**AMENDMENT 006
INVITATION TO TENDER**

**OPERATIONAL CENTER REHABILITATION AND CONSTRUCTION OF
AN ADMINISTRATIVE BUILDING - PARC FORILLON (QUÉBEC)**

The purpose of Amendment 006 is to answer questions, to postpone the closing date and to add addenda.

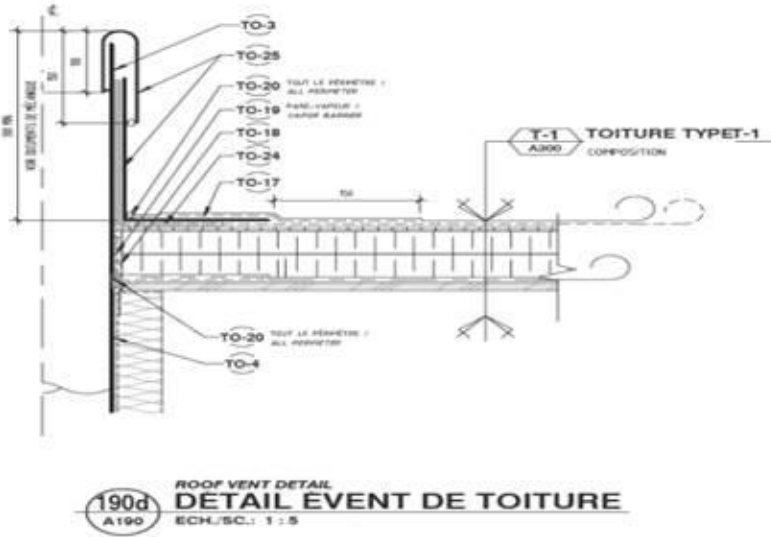
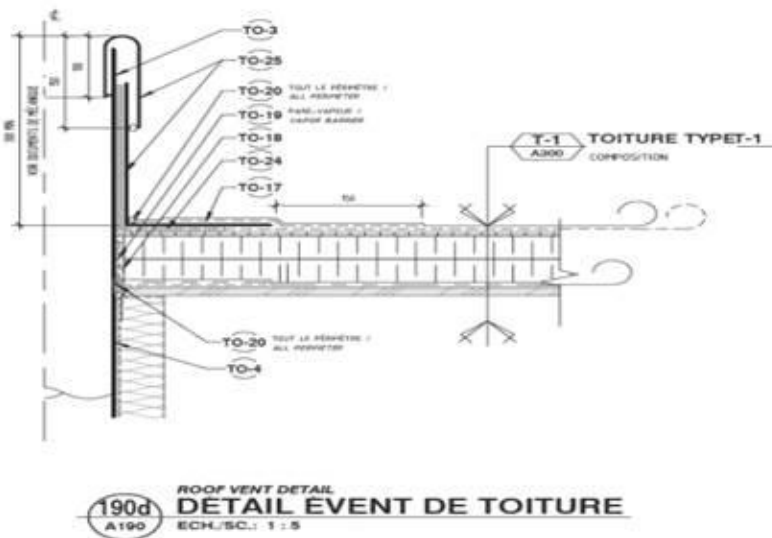
plans d'architecture (A190) il y a une référence à ce détail qui selon nous ne correspond pas à un détail d'évent. Pourriez-vous clarifier ?	
72 (EN)	Plumbing: In the plumbing plans and specifications, there is no model of roof flashing for the exit of plumbing vents and on the architectural plans (A190) there is a reference to this detail which in our opinion does not correspond to a vent detail. Could you clarify?	ADDENDUM-EM-04
73 (FR)	<p>Question en plomberie : Dans la légende T0-3 qui fait référence aux détails 190D</p>  <p>Est-ce que vous pourriez préciser la marque et modèle des solins requis pour le projet?</p>	Addenda EM-04
73 (EN)	Plumbing: In the T0-3 legend that refers to details 190D	ADDENDUM-EM-04

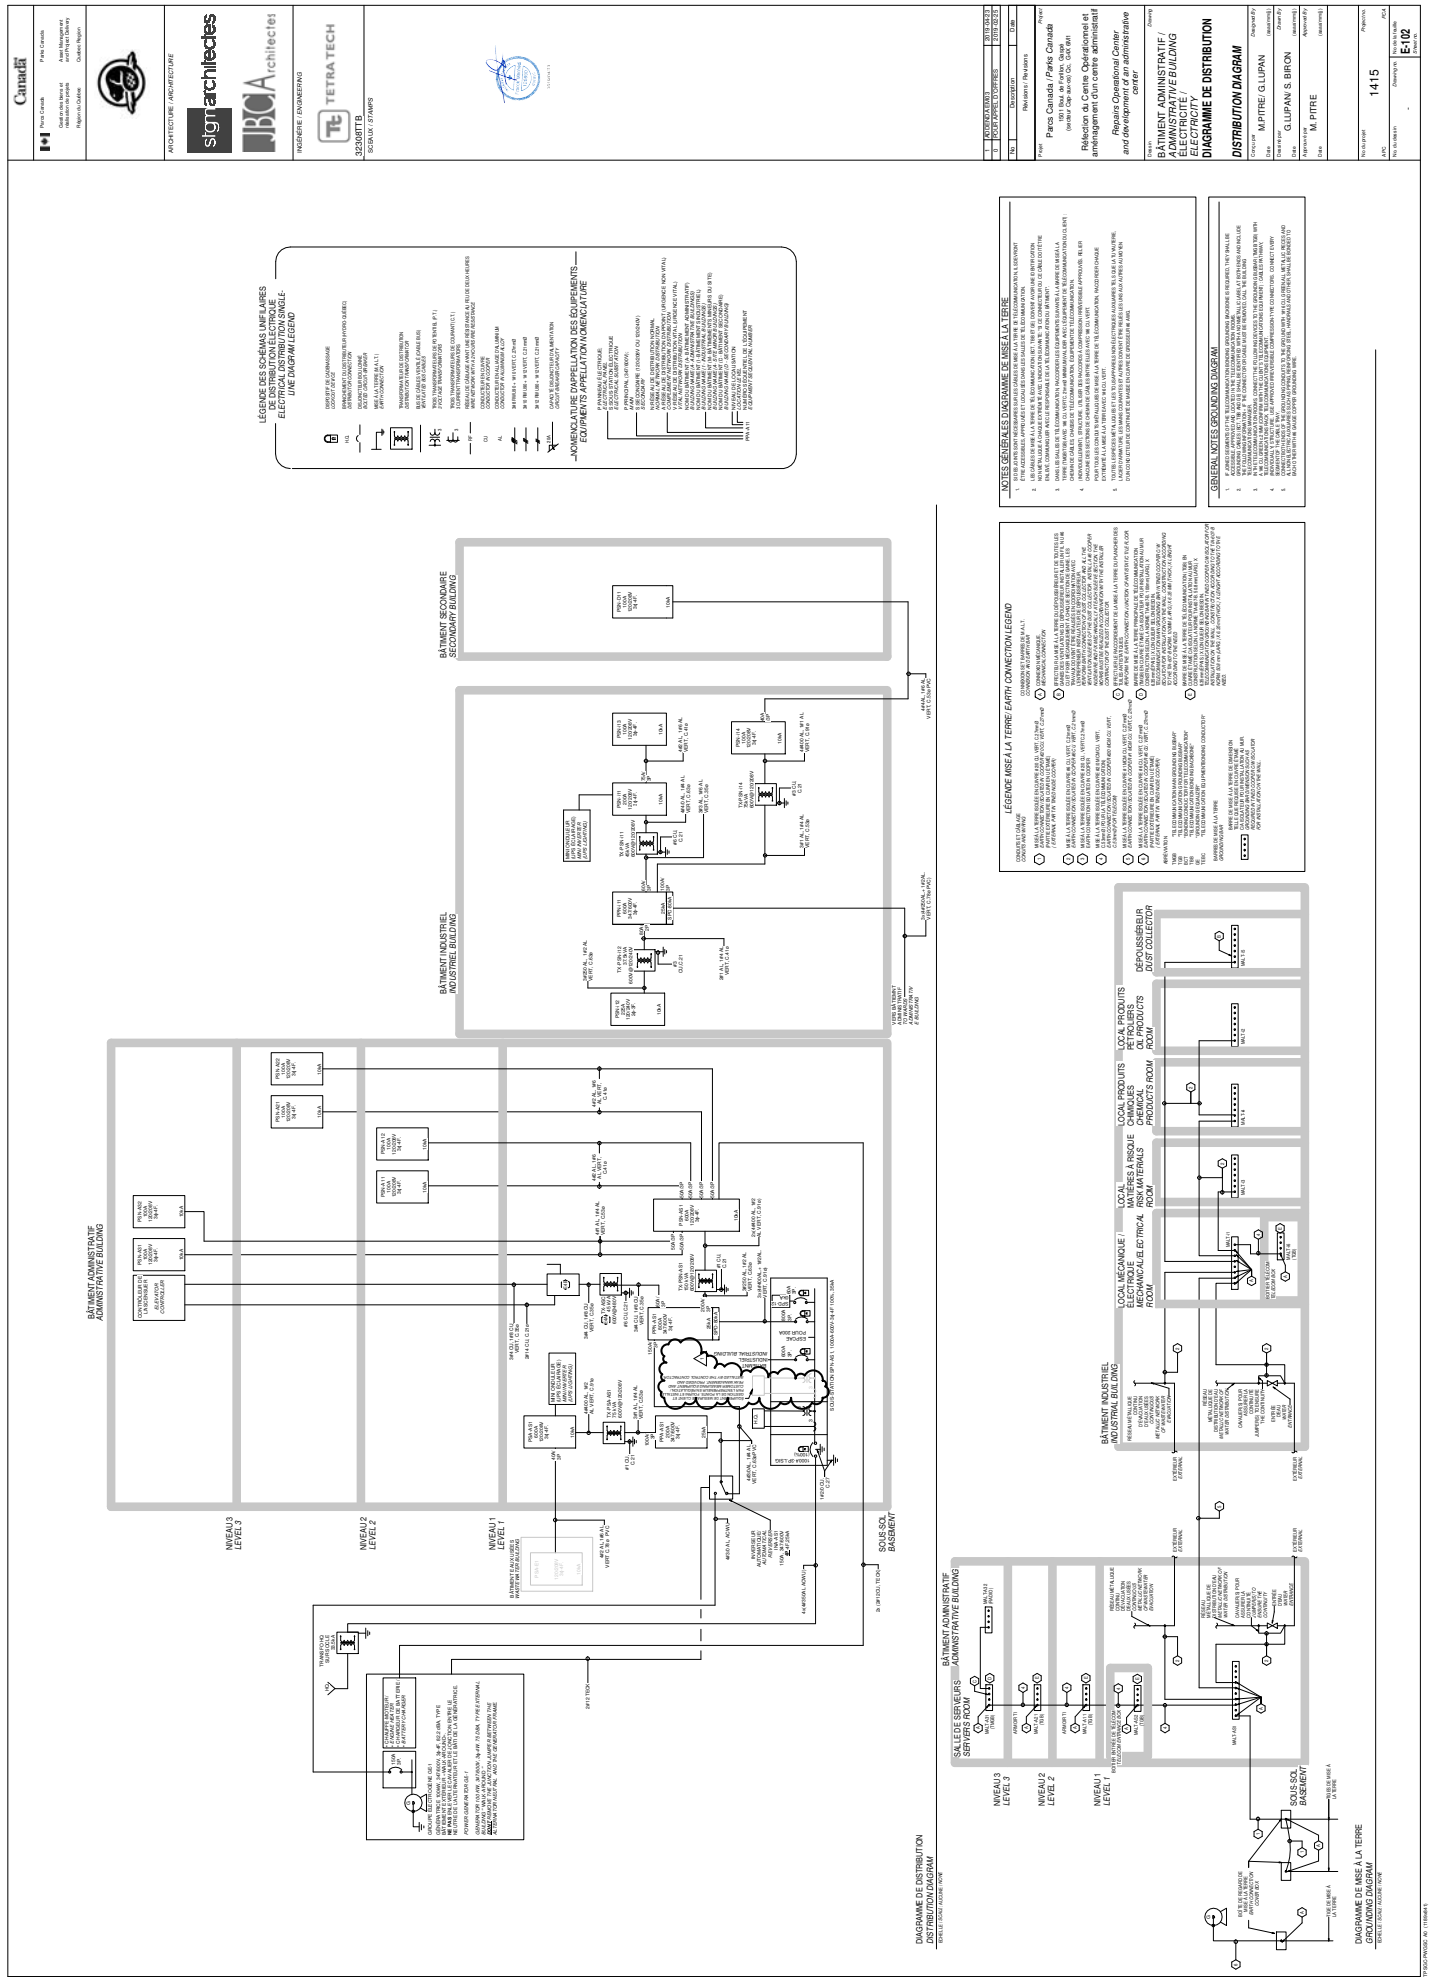
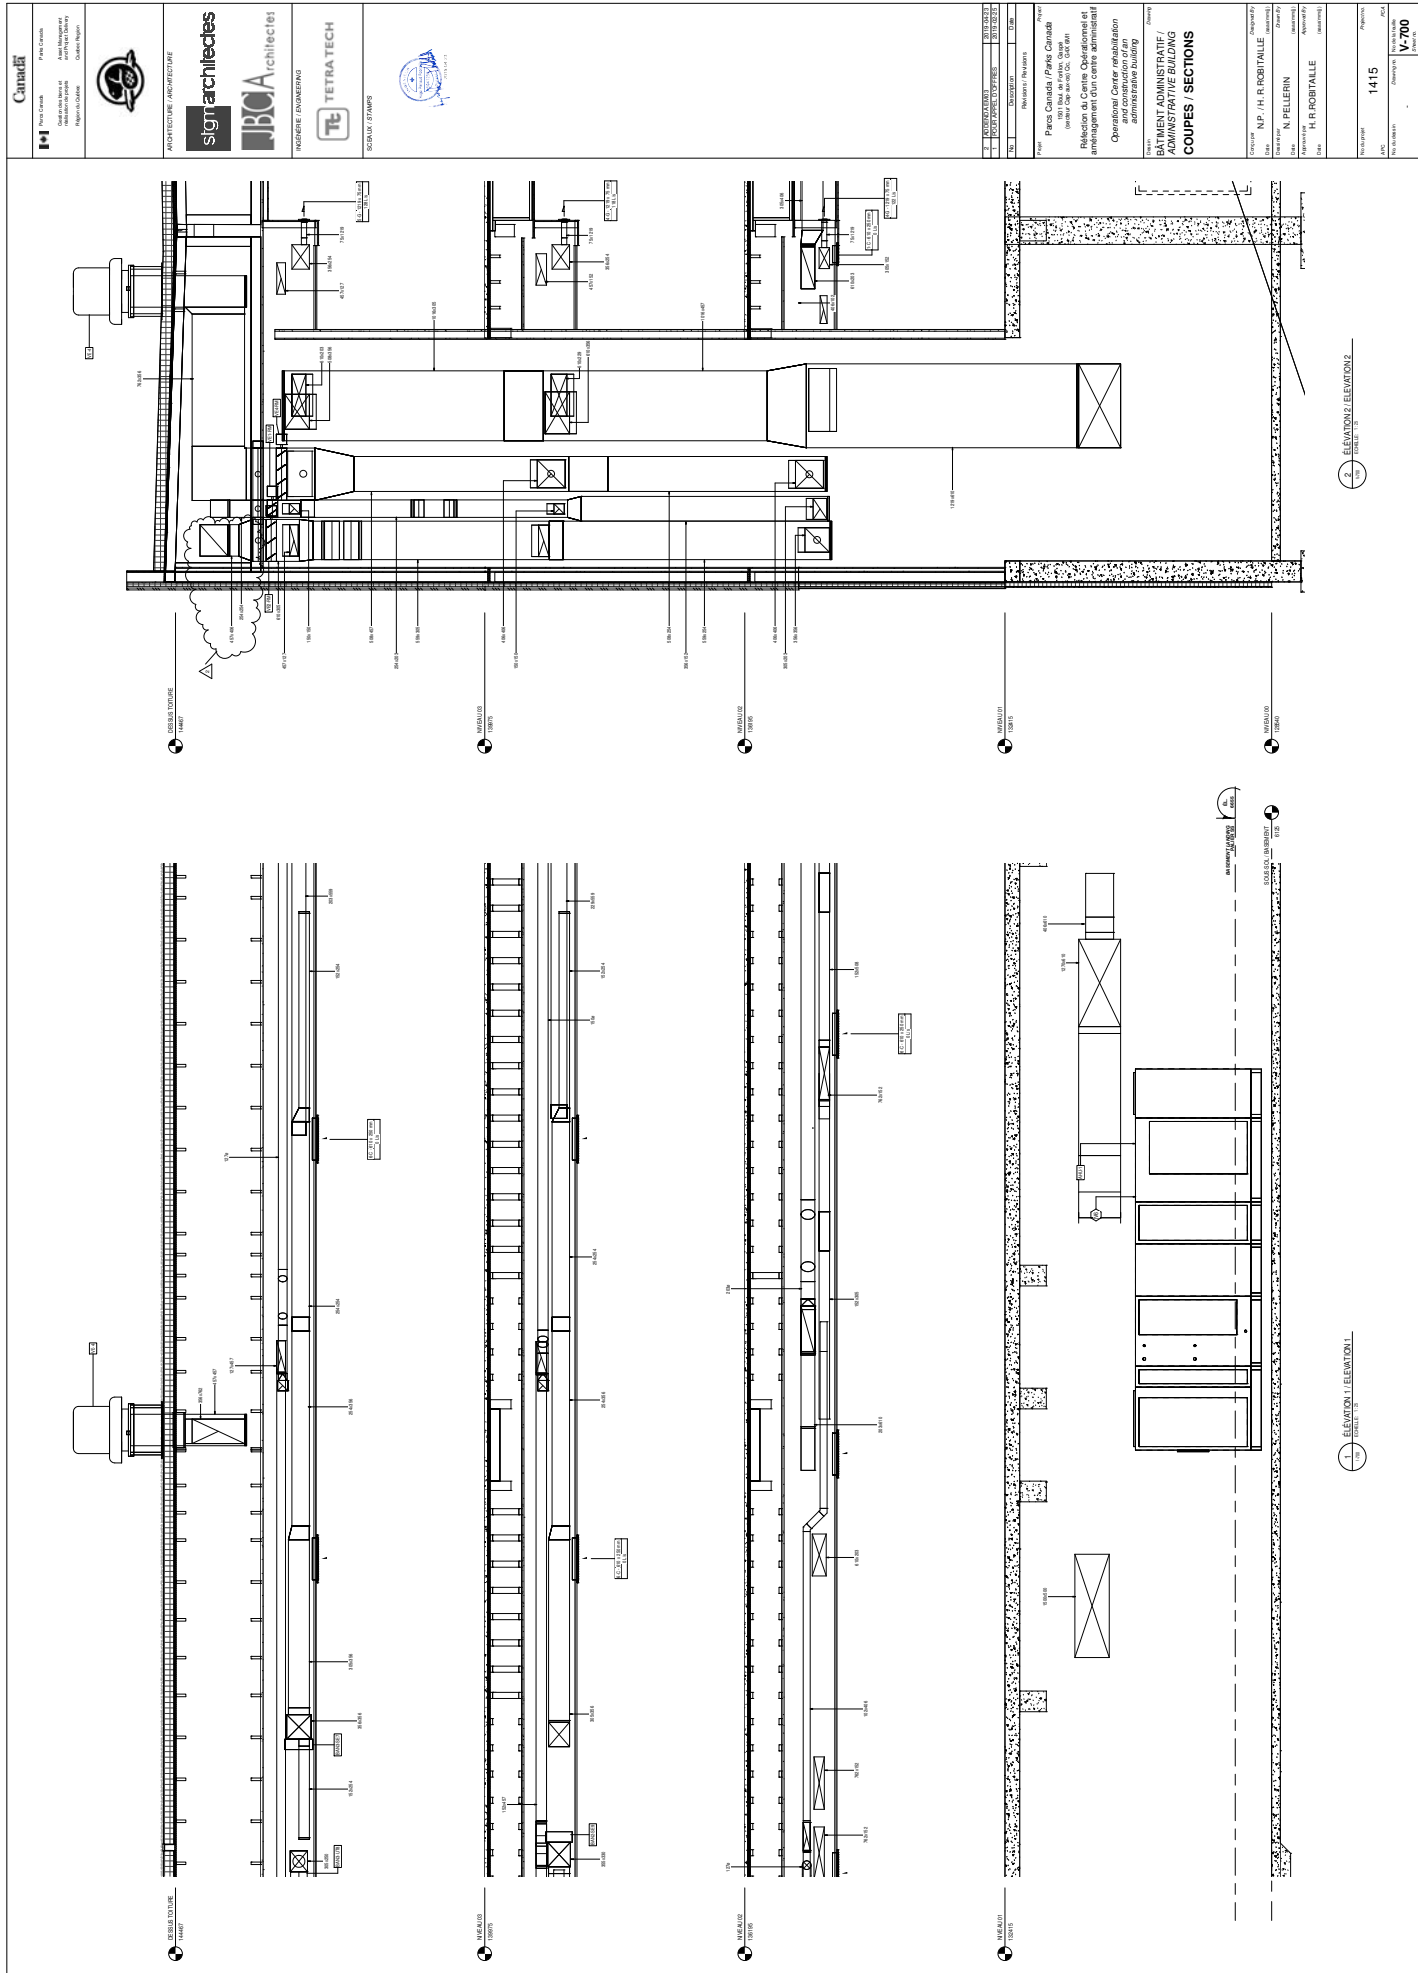
1. The revised plan is released again (see attachement). Cloud marks show the modifications.
